# Service Bulletin

Bulletin No.: 24-NA-099

**Subject: Clunking Noise from Front of Vehicle**

6665042

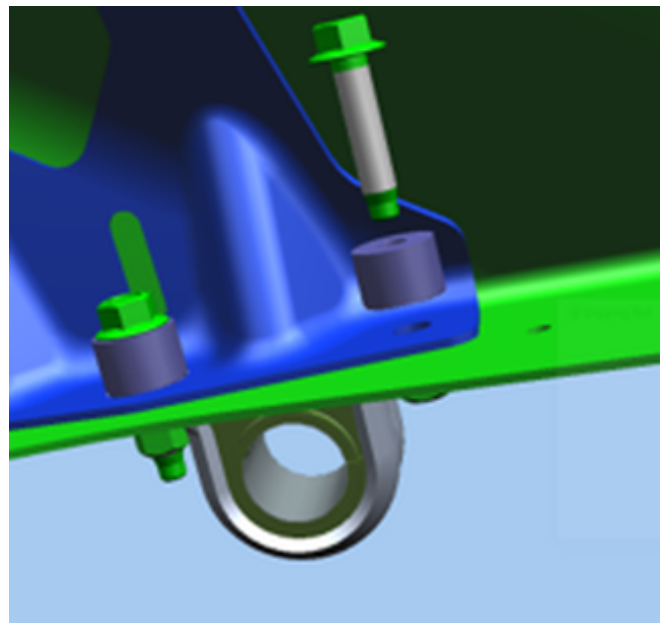
1. Loosen all four stabilizer bolts.
  - It may be necessary to cut off the affected bolt if it has not entirely separated from the retaining nut.
2. At the affected frame access hole, inspect area inside frame and clean area of any debris and ensure the retaining bolt that has broken loose is removed from the frame.
3. Install the spacer onto the bolt.

- ⇒ To aid in installing the bolt/spacer assembly, insert approximately a 18" length of 3/8 shrink tube through the stabilizer bracket bolt and frame hole being repaired, with tubing pulled through the frame access hole ensuring there is an adequate length of tube exposed.
4. Attach upper tubing to approximately 3 to 4 threads of the bolt/spacer assembly.
    - ⇒ Ensure the shrink tube is sufficiently secure to the bolt.
